Planning and Zoning Commission

April 2, 2019

**3401 SE Destination Drive Site Plan
Lot 3 & 4 – Crossroads Business Park of Grimes Plat 4
Grimes, IA 50111**

FOX Engineering has completed the second review of 3401 SE Destination Drive Site Plan dated March 27, 2019. Please address the following comments:

GRADING PLAN

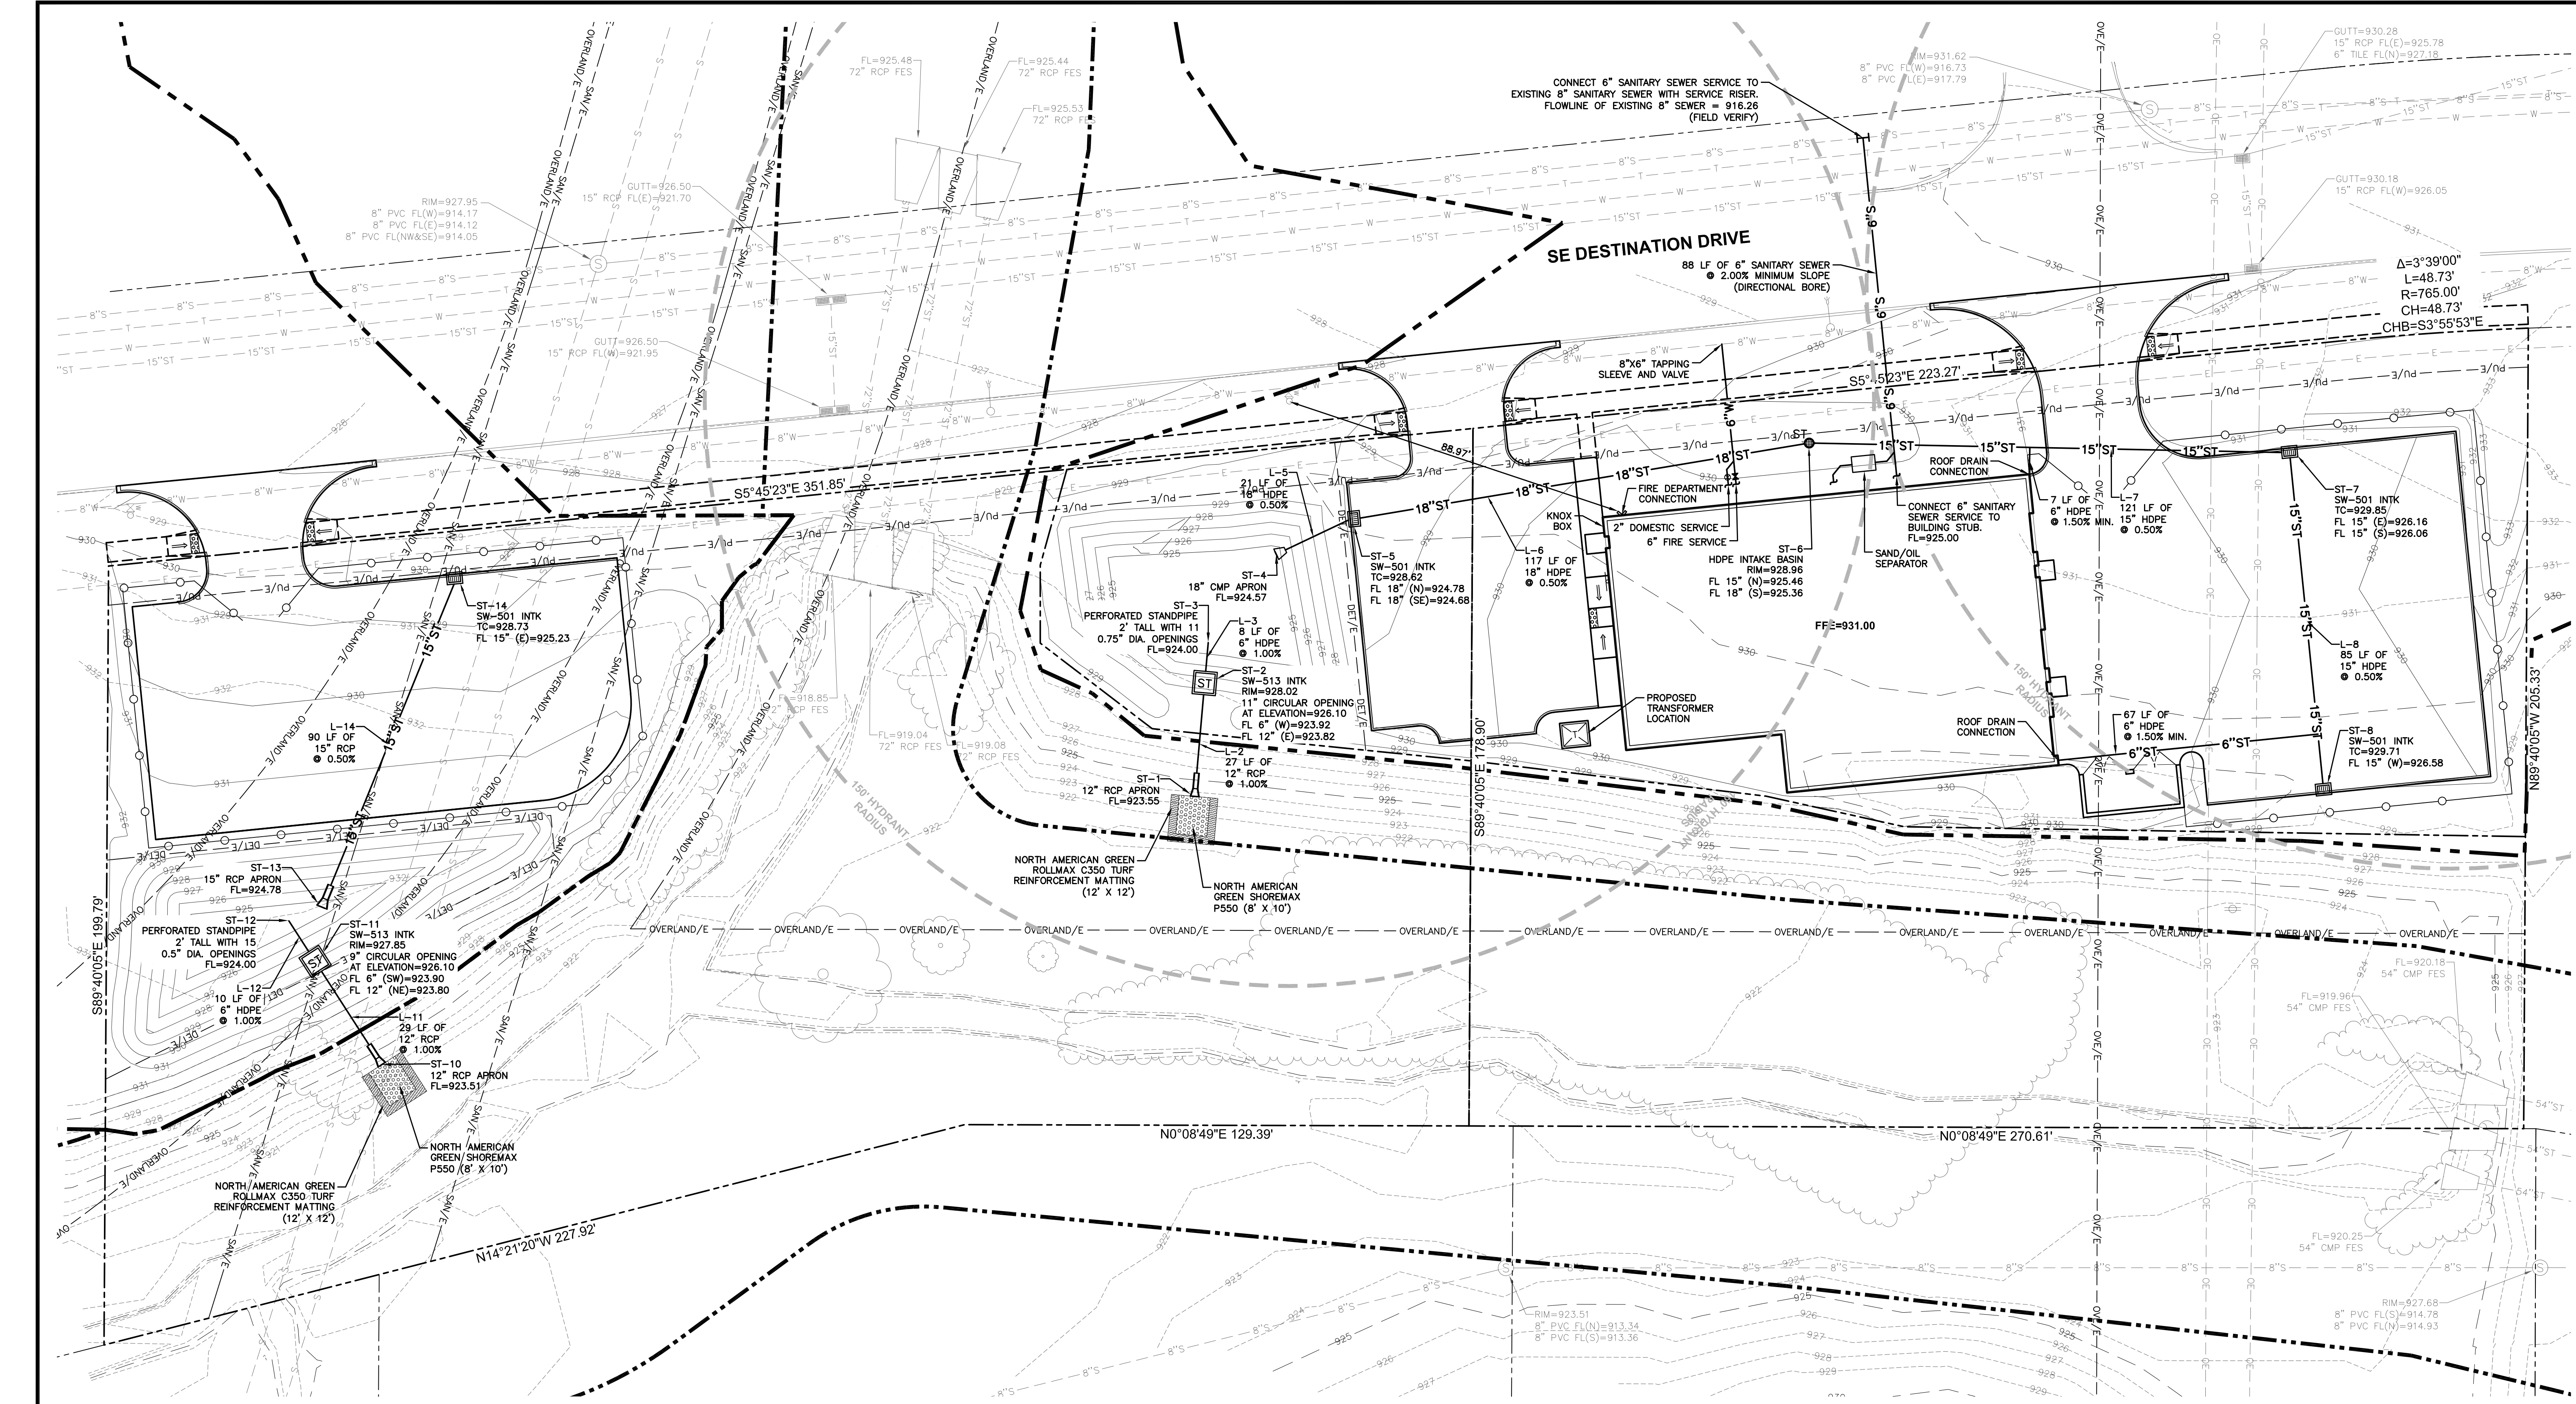
12. The detention plan for the Lot 3 parking lot shows substantial cut over the existing sanitary sewer force main. Please provide exploratory potholing of the existing force main to verify that the force main will retain a 5-ft (minimum) bury depth.

13. Parking Lot 4: Please provide additional spot elevations and/or percent slopes around the ADA stalls. Please include driveway crossing slope/elevation labels with enough information to verify that the future sidewalks will meet ADA guidelines (cross slopes <2%). Please include slope labels at the north/south extremes of the pedestrian crossings. It looks like the north edge cross slope of the Lot 3 driveway and the south edge cross slopes for both Lot 4 driveways are pushing the extremes of what is allowed by ADA.

14. Please show/label/dimension the emergency overflow for the Lot 3 detention area. Please dimension the emergency overflow width for the Lot 4 detention area. Please include spot elevations for both spillways to verify spillway elevations. It appears that the Lot 4 spillway elevation does not match what is in the SWPPP narrative. The emergency overflows shall be sized for the 100-yr proposed condition in the event that the outlet is plugged.

3401 SE DESTINATION DRIVE
UTILITY PLAN

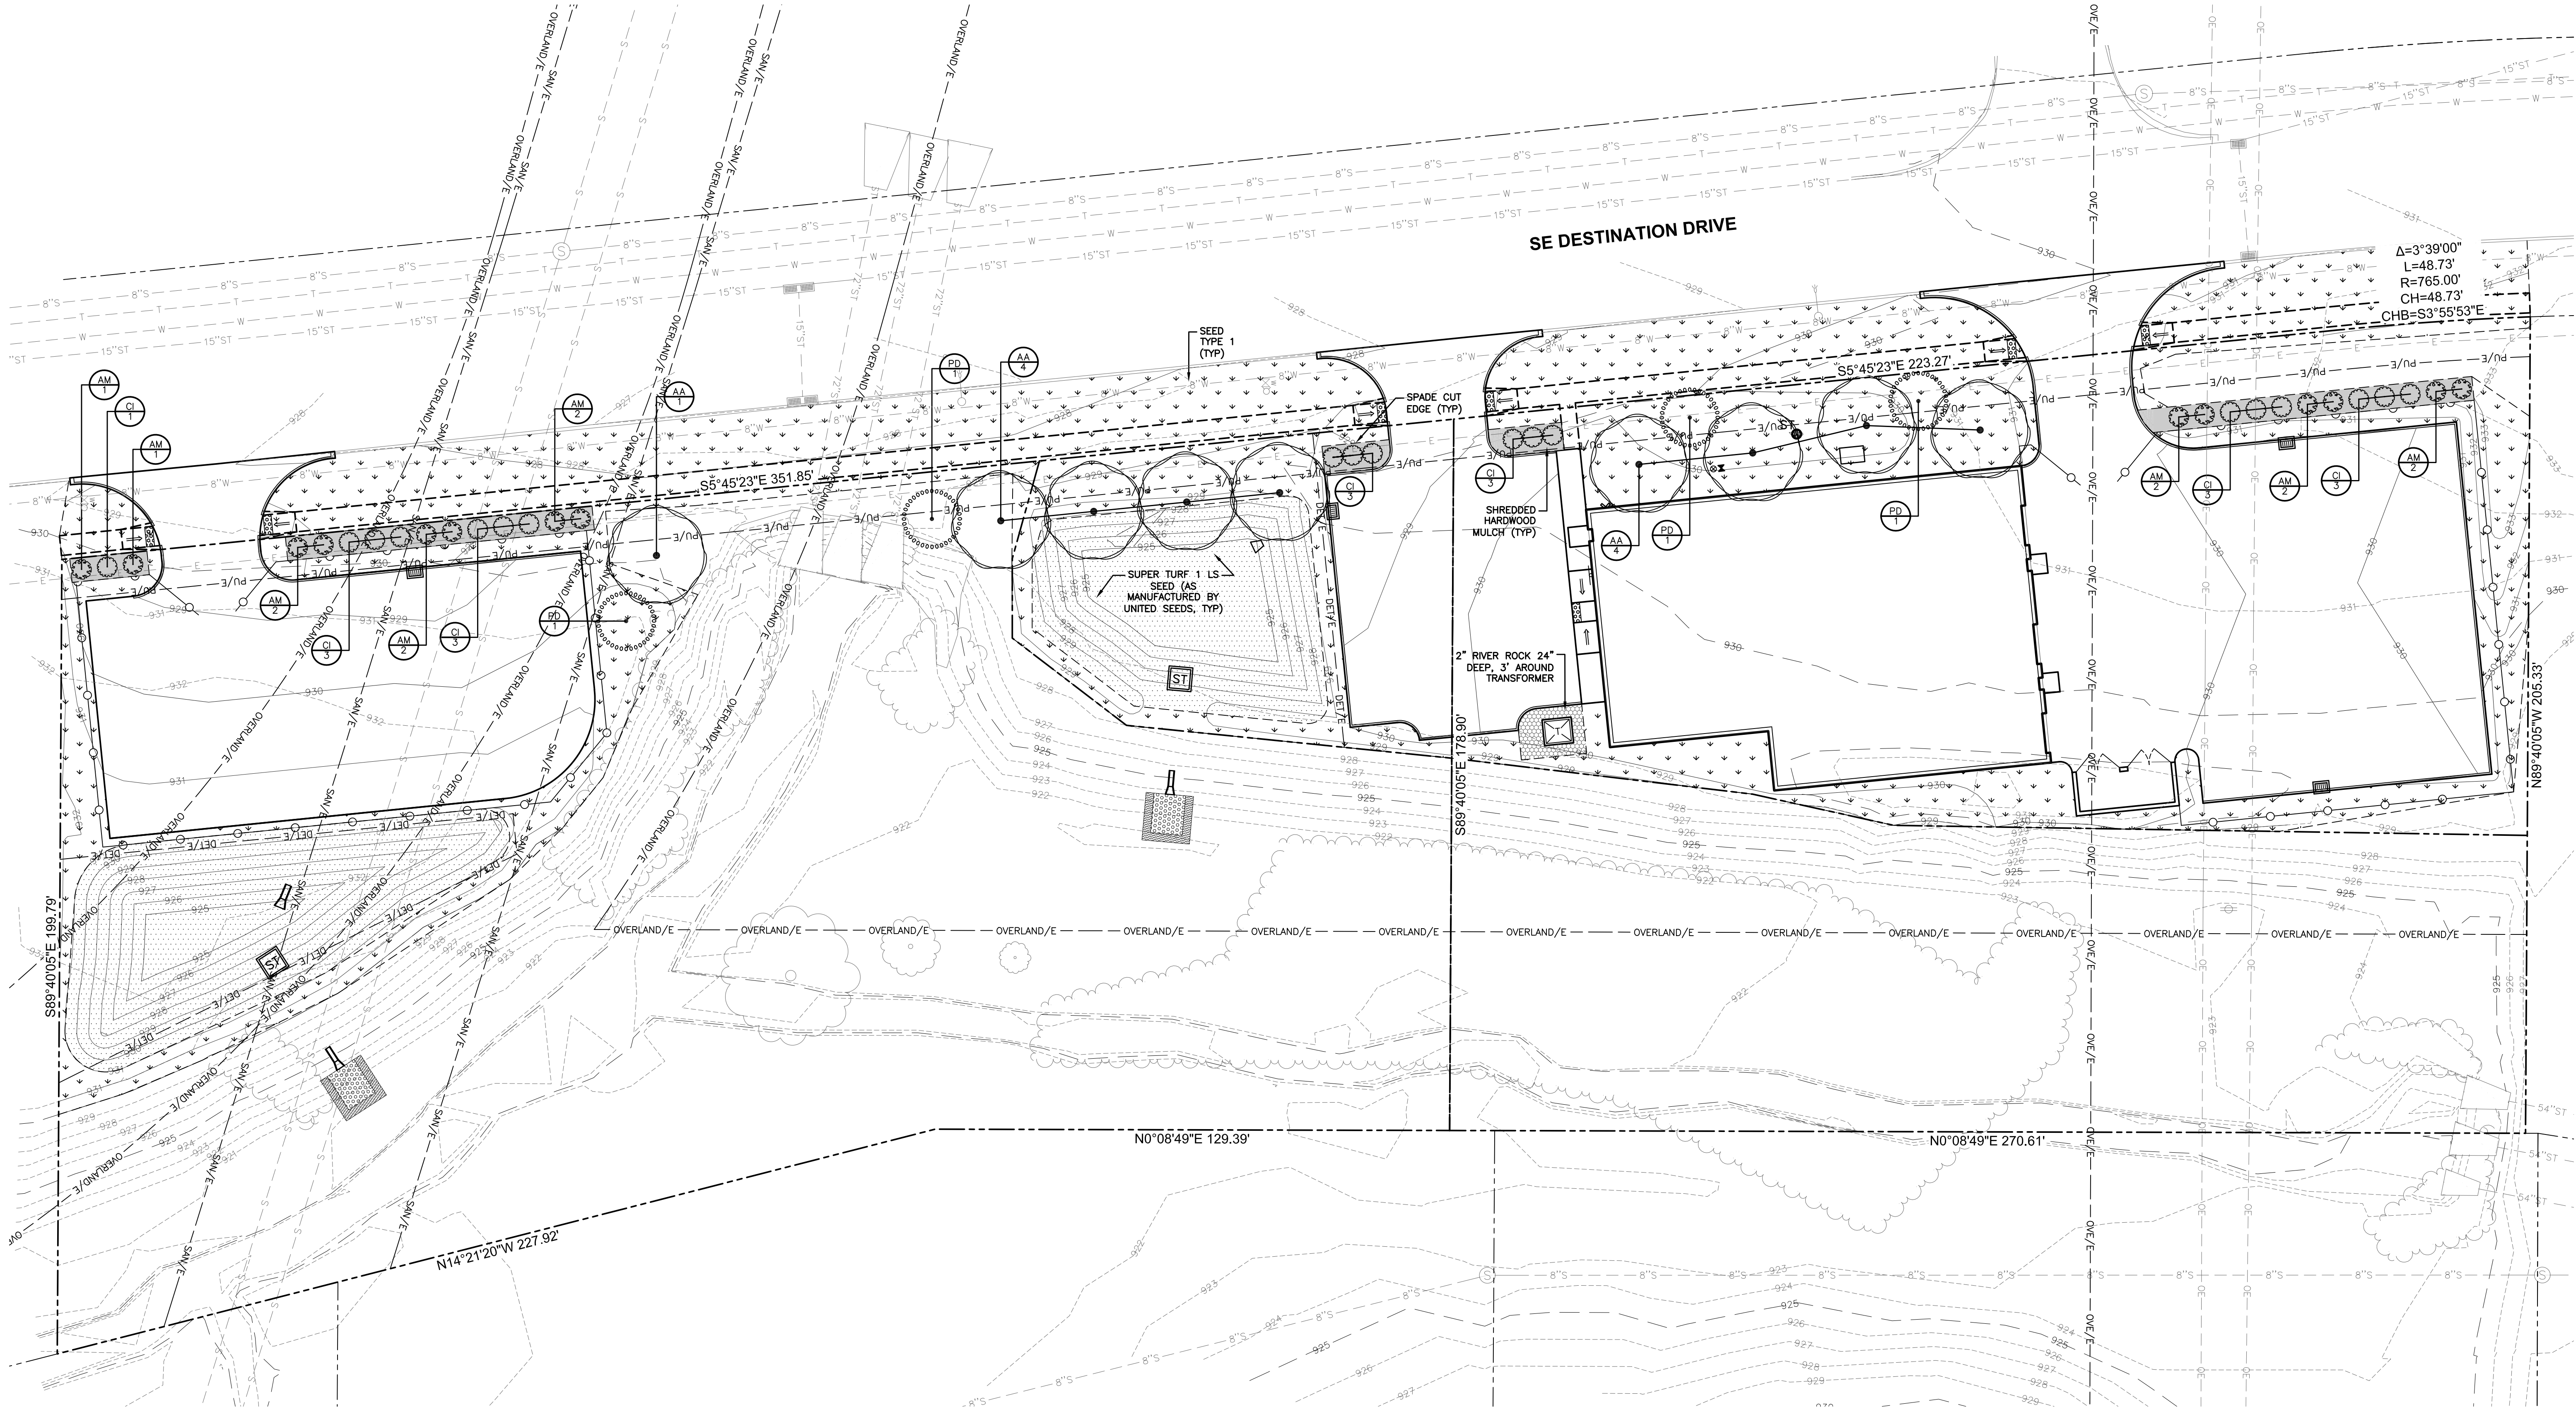
16. Fire Hydrant Coverage: The proposed fire hydrant projection is greater than 150-ft. The fire chief will need to review and comment.
17. Discussion is necessary as to whether the building will be a single or multi-tenant structure. The following comments are from Thorpe Water Development Company and should be addressed:

- a. If this is a single tenant building: Thorpe Water would require one meter, based on fixture loads, not based on service line size.
 - b. If this is a multi-tenant facility: Thorpe Water will require separate curb valves outside of the building. For each additional meter, Thorpe requires to be able to terminate water service for nonpayment of sewer or water without gaining access to the interior of the multi-tenant building.

18. Please show the proposed working limits along the west side of the SE Destination Drive ROW and how the area will be stabilized. Discussion is necessary if the connection to the sanitary sewer should be from the existing sanitary sewer east of the building (off-site property in easement).

**WEST BUILDING
ELEVATION**
(100% BRICK)

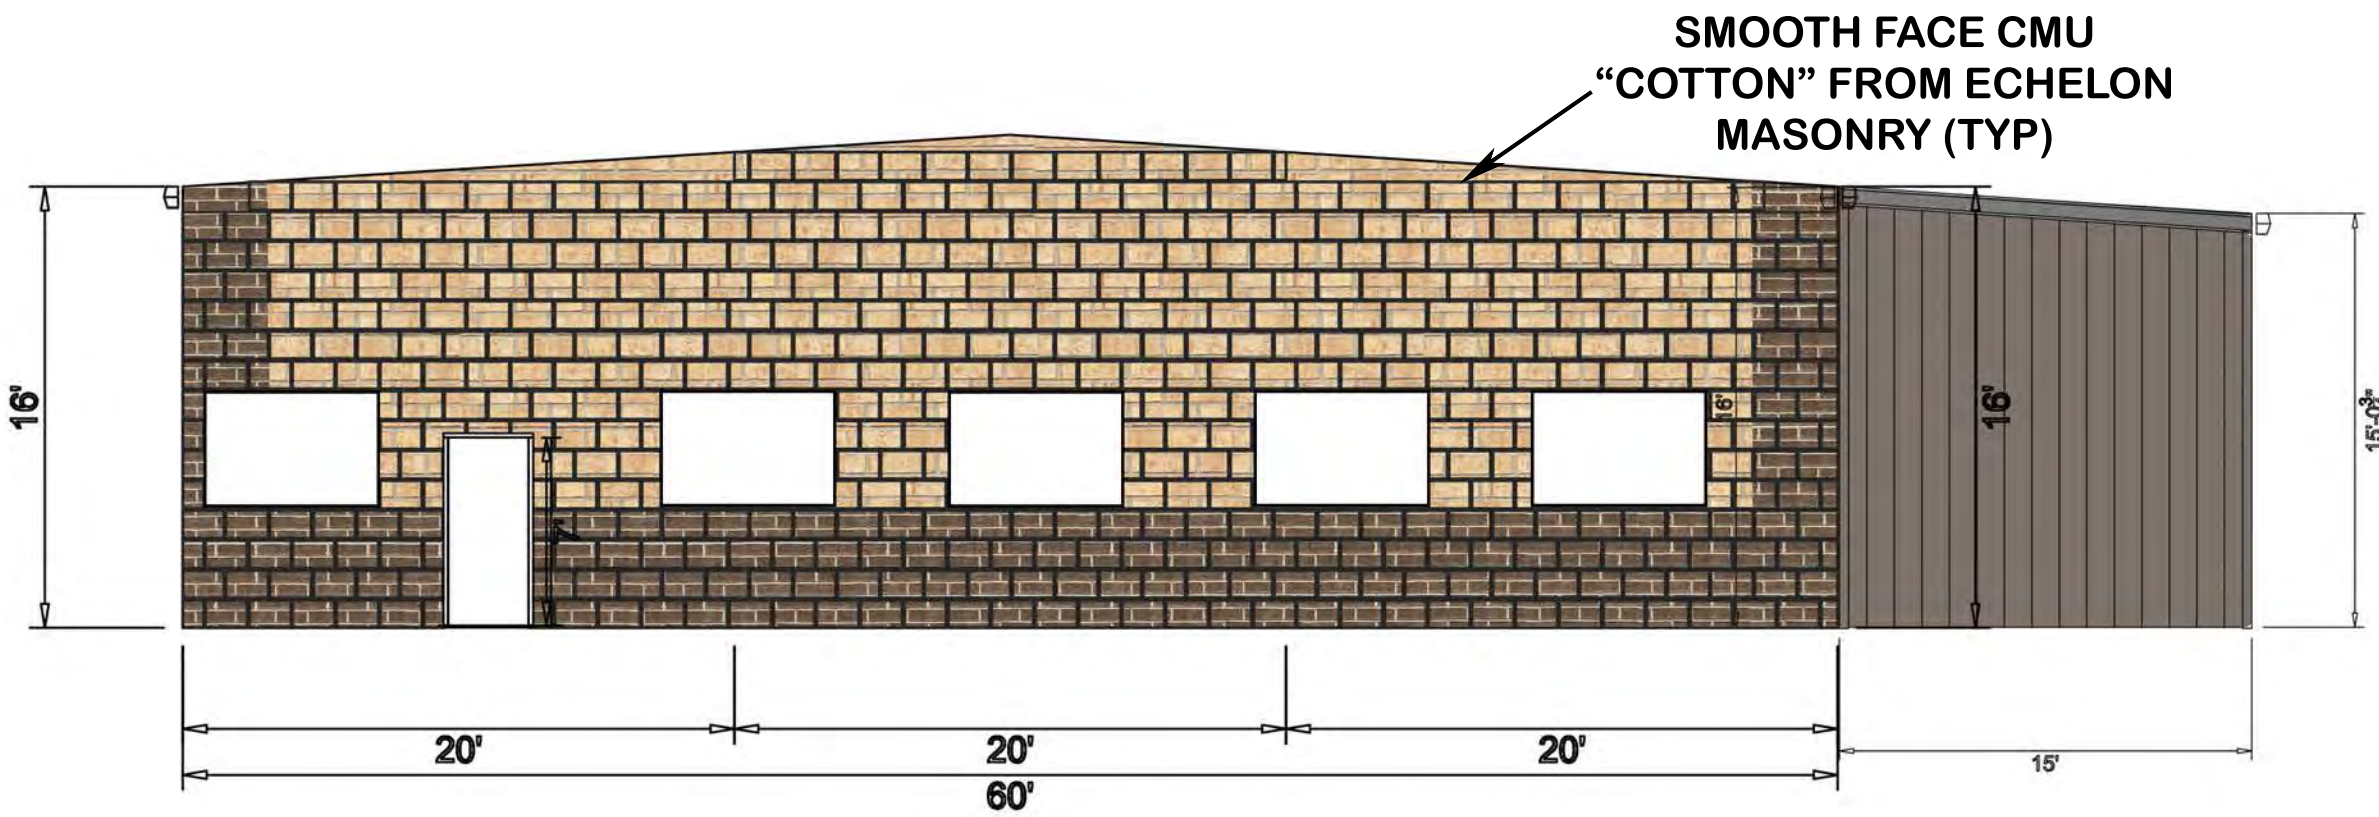
20. Please revise the percentage of brick shown for the west building elevation. Percentage of brick should account for windows (thus making the area of brick less than 100%).

22. The west side of the building (facing Destination) exceeds the brick requirement, thank you! Discussion is necessary at P&Z whether the provided architectural banding and color variation meets the intent of the Grimes Code.
